AGENDA  
Village of Chenequa  
Monday, June 9, 2025  
31275 W County Road K, Chenequa, WI 53029

## STAFF REVIEW

**Subject:** Site Plan Review

**Project Description:** Proposed Accessory Structure

THIS SURVEY PREPARED ON FEBRUARY 12, 2021 WAS UPDATED TO SHOW PROPOSED BARN AND SHED ONLY. NO FIELD WORK WAS COMPLETED.

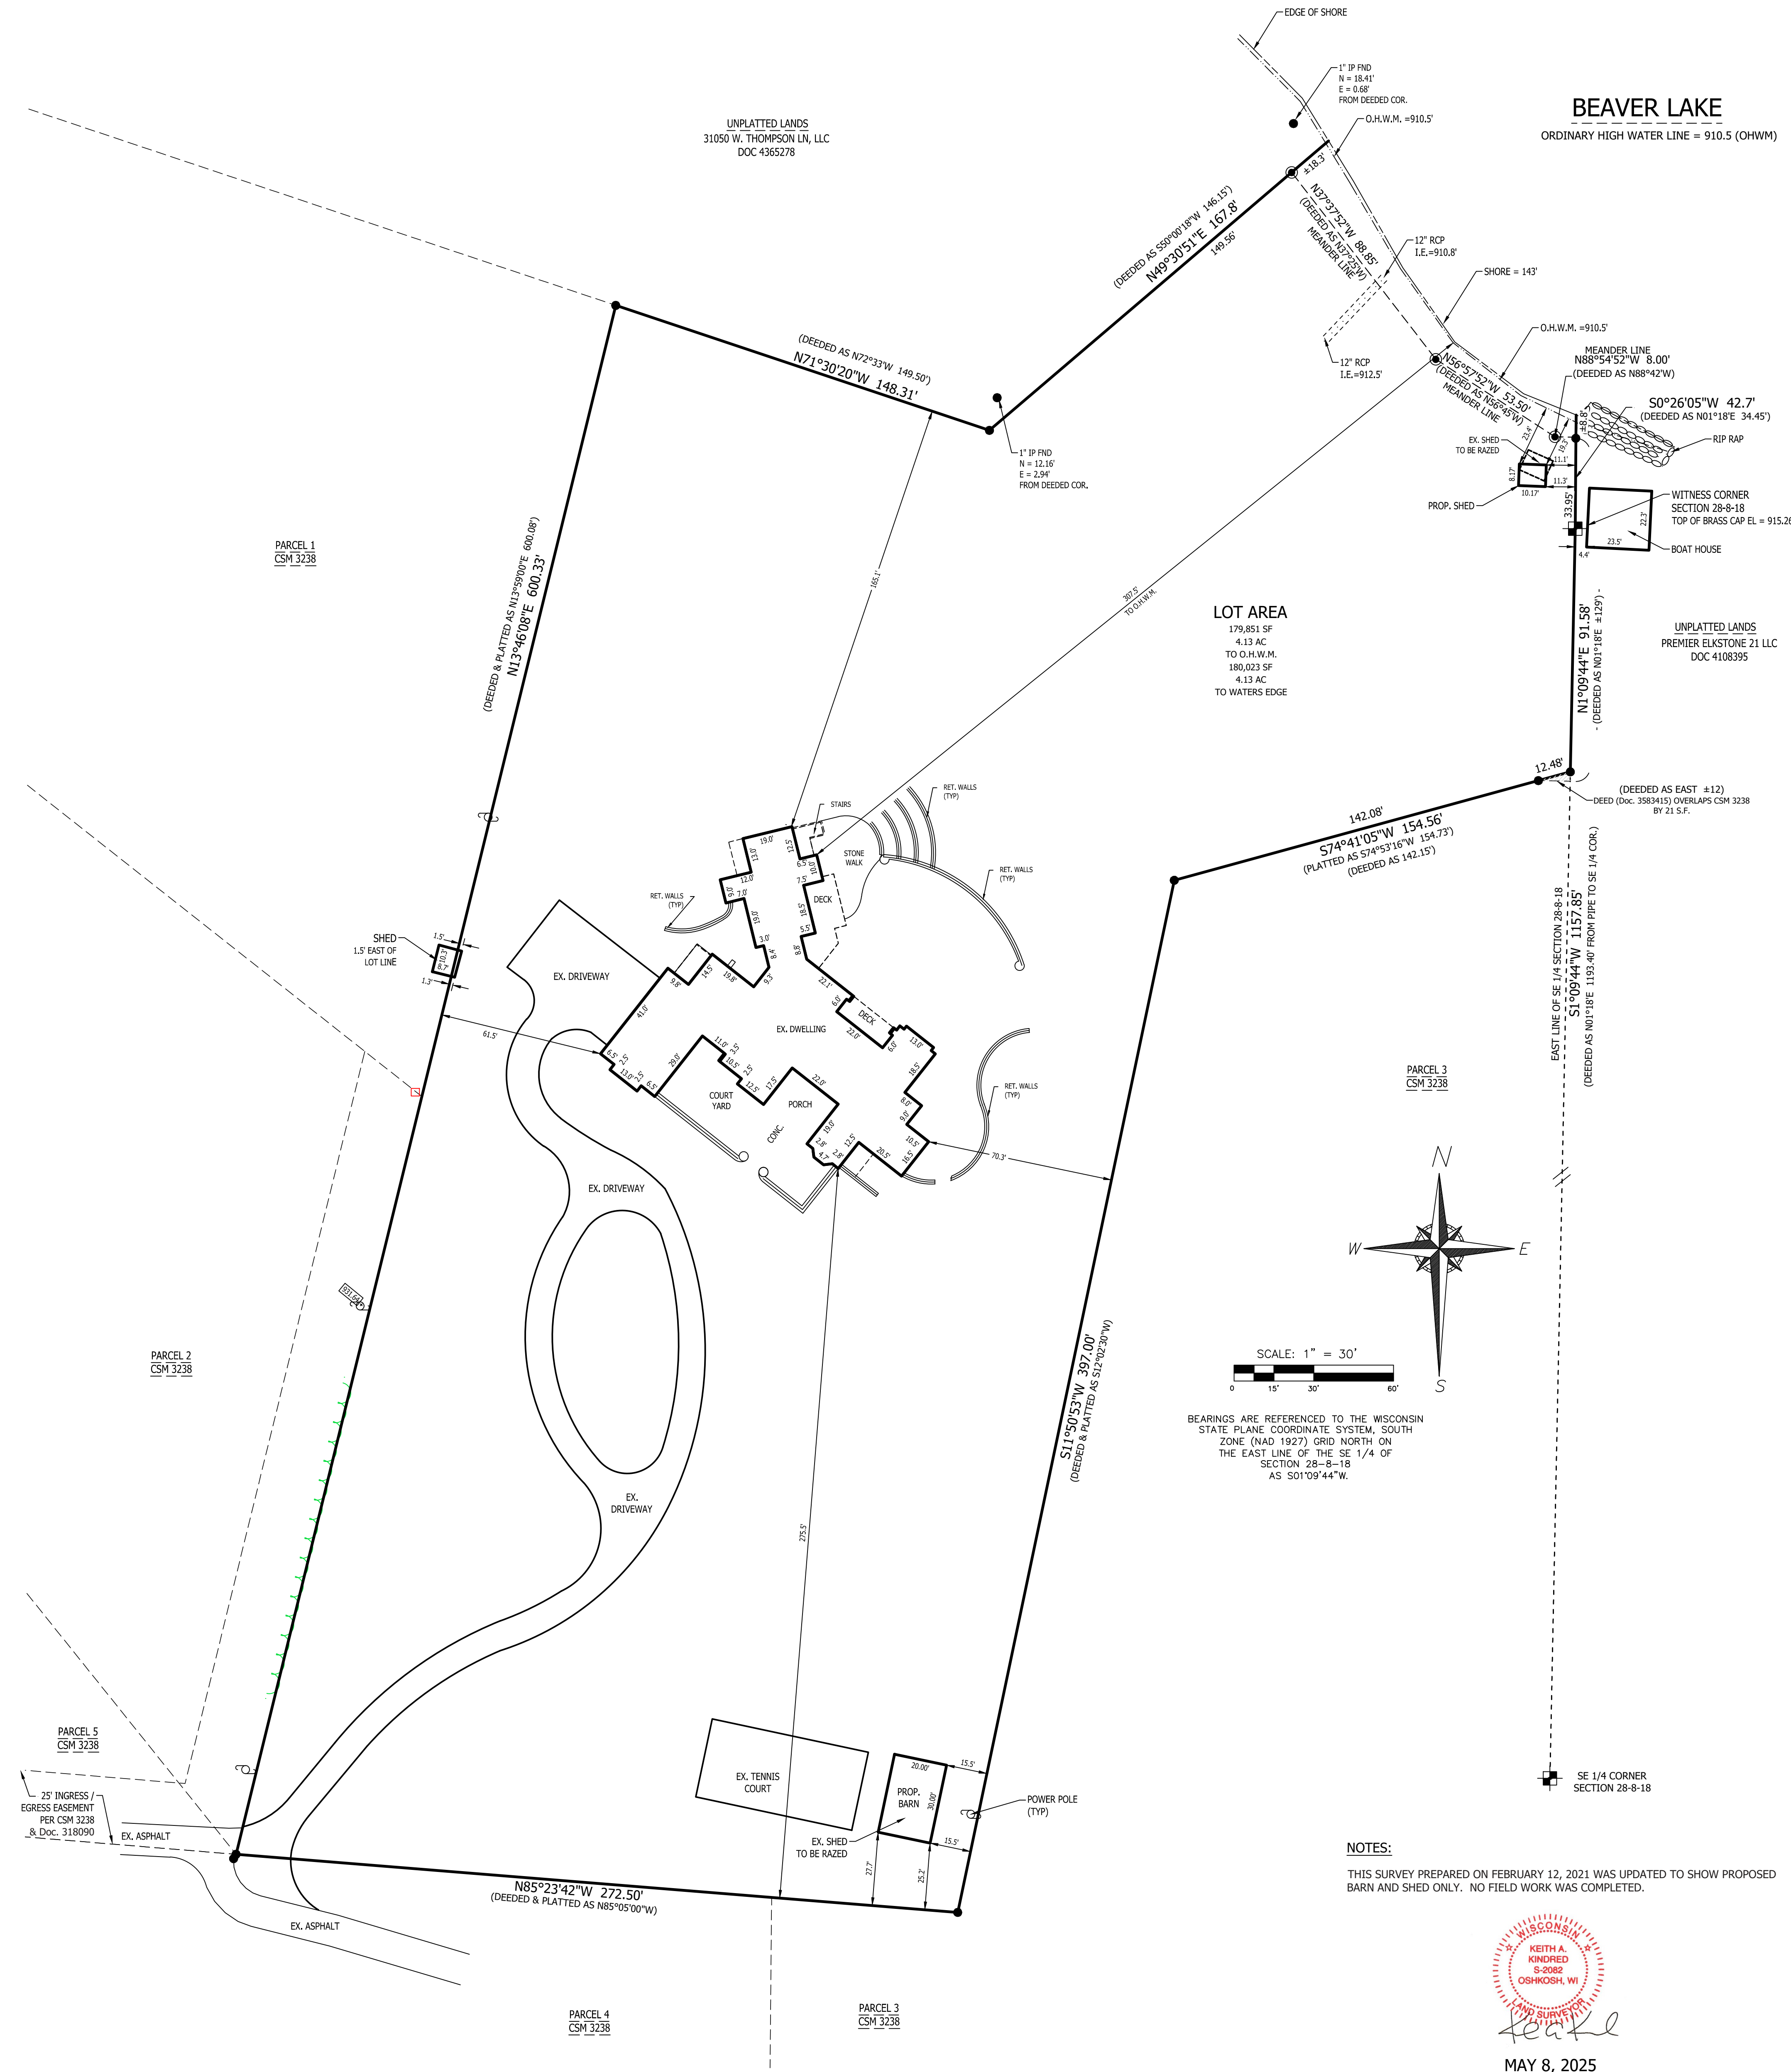
1. The applicant proposes to raze an existing accessory structure and build a new one in its place.
2. The new proposed accessory structure will be 600 square feet.
1. 6.5(c) specifies that "The maximum footprint of all accessory buildings erected, modified or moved on any lot shall not exceed two percent of the total lot area".
  - a. The maximum allowable footprint of all accessory buildings on this property is 3,606 square feet

- b. The total footprint of the two accessory buildings on the property will be 683 square feet.
- 2. The proposed accessory structure would be over one hundred (100) feet to any existing single-family structure on an adjoining lot which complies with Sec. 6.5(4)(c)(i).
- 3. Exterior finishes are detailed in supplied packet.
- 4. For exterior lighting, the applicant proposes to install three 2700K (8W) soffit lights.
- 5. A building permit is required from the Building Inspector prior to start of construction.

QUADRACCI FLORES  
ENTRY PILLAR PLAN REVIEW  
CHENEQUA, WI

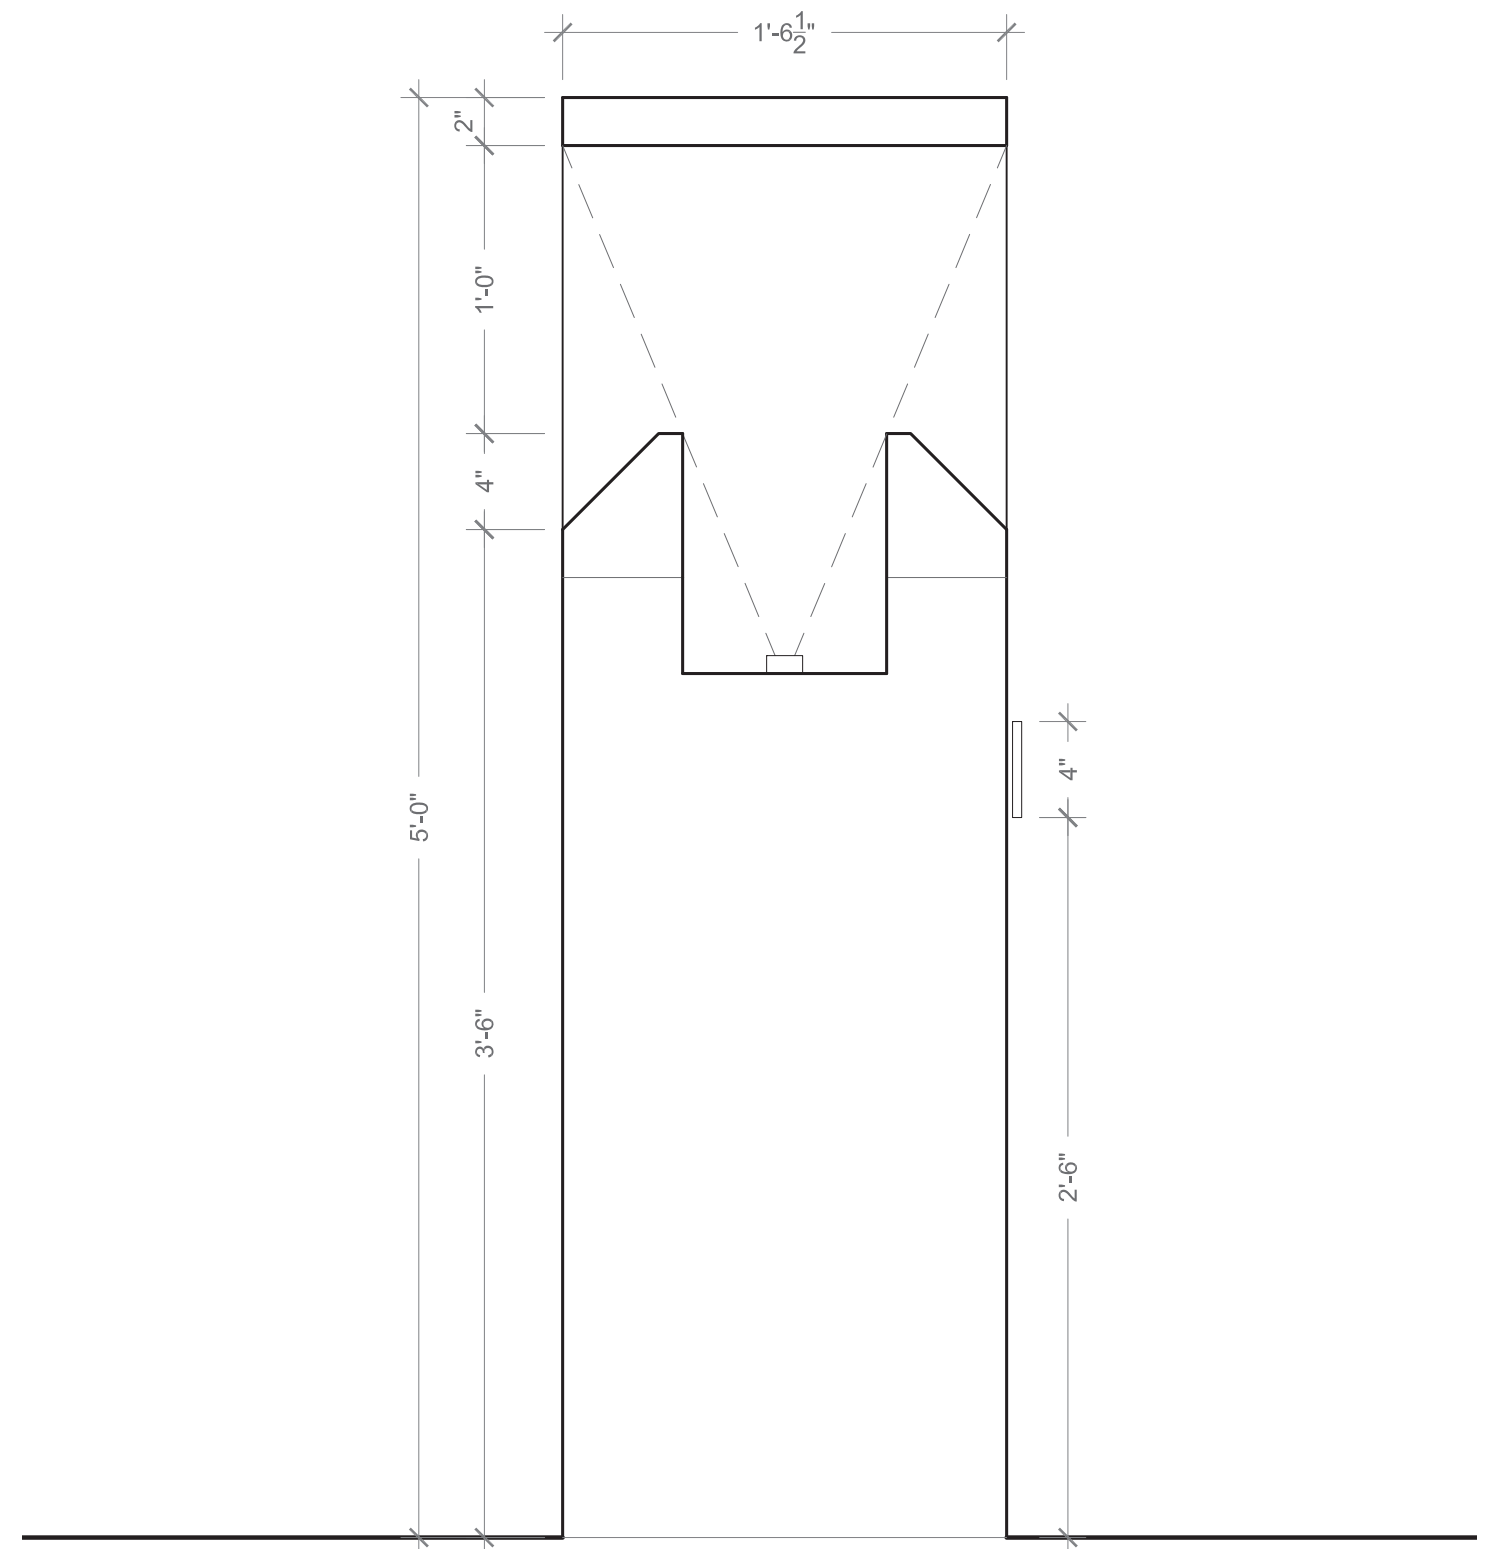
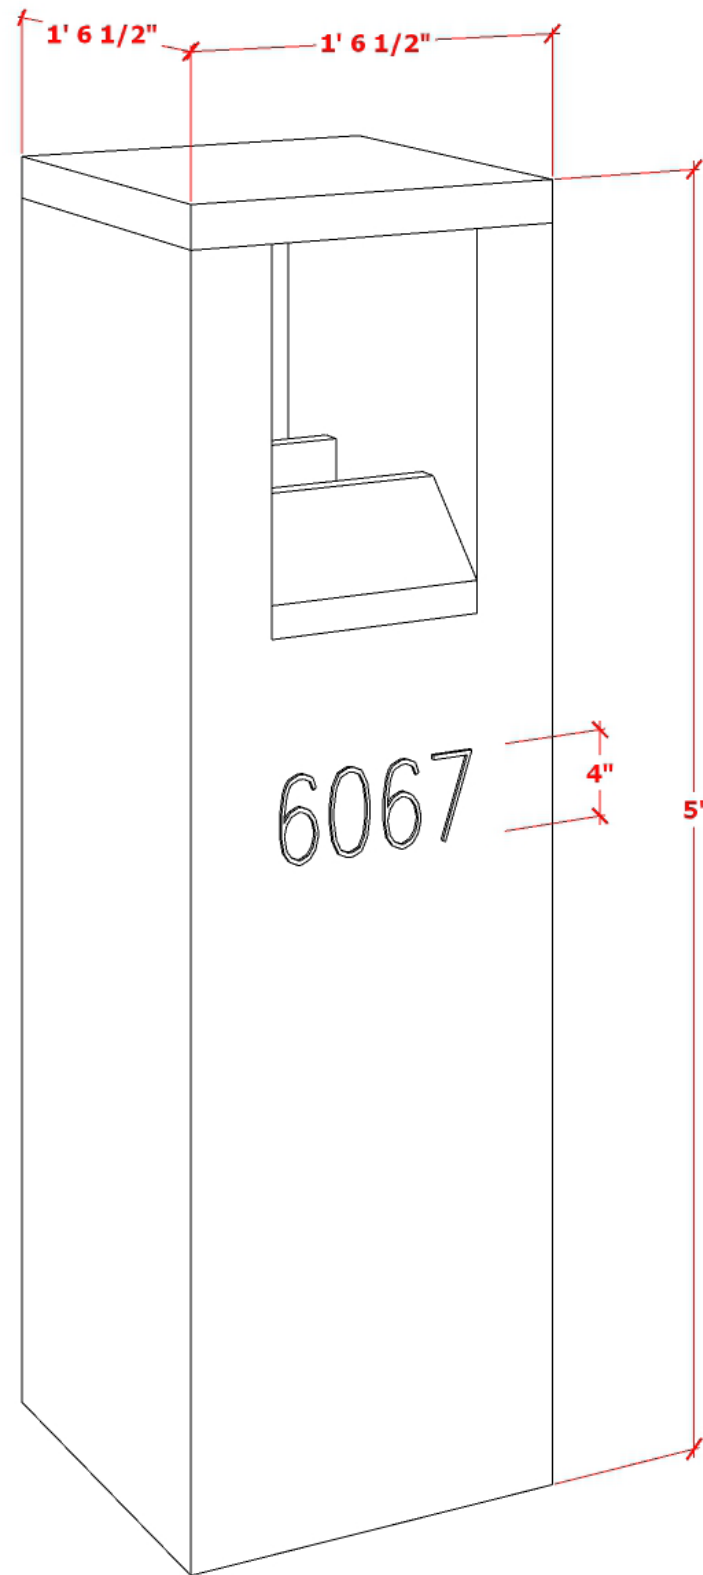
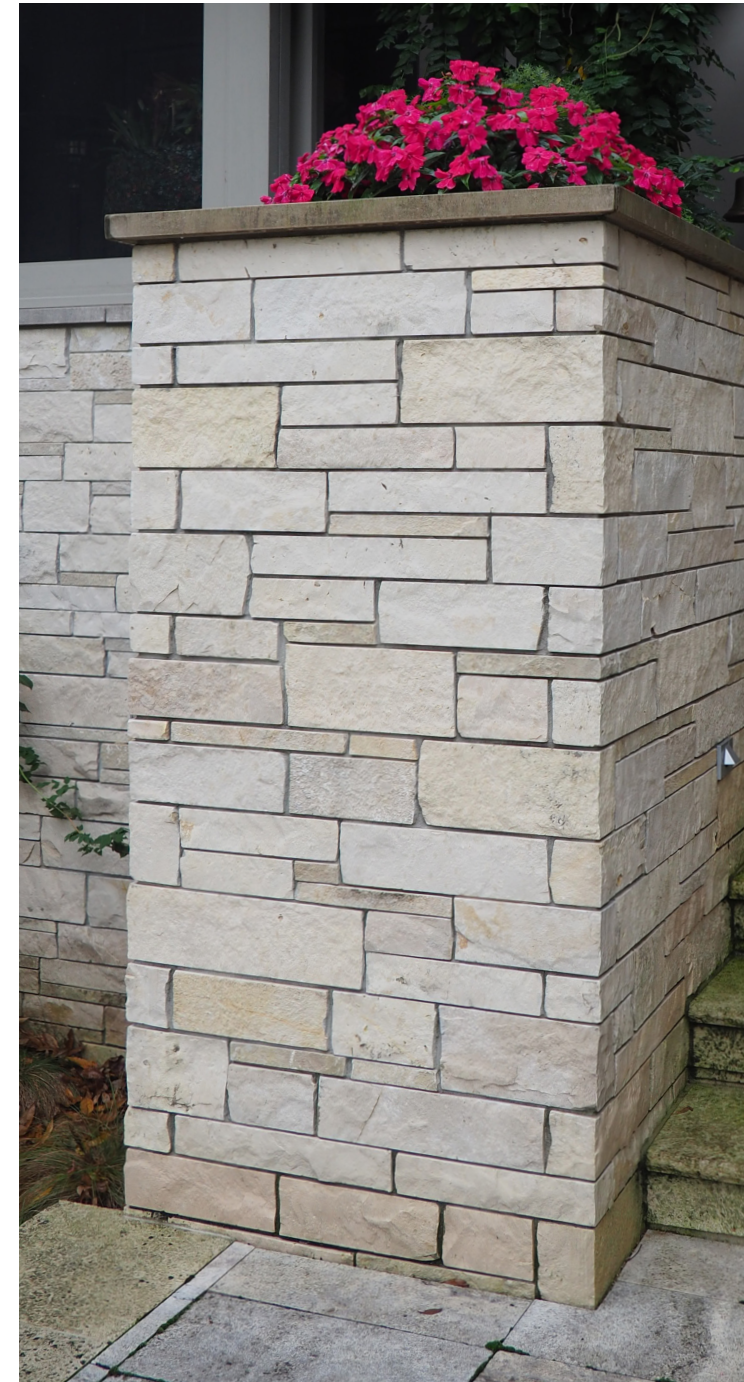
1. The applicants are proposing to replace existing entryway pillars that are currently adjacent to STH 83
2. According to 5.20(1) *“All permit applications shall be referred to the Plan Commission and shall be considered as to appearance, materials, design, location, height and harmony of the proposed fence with the principal structure on the lot and structures on neighboring lots so as not to adversely affect property values in the neighborhood.”*
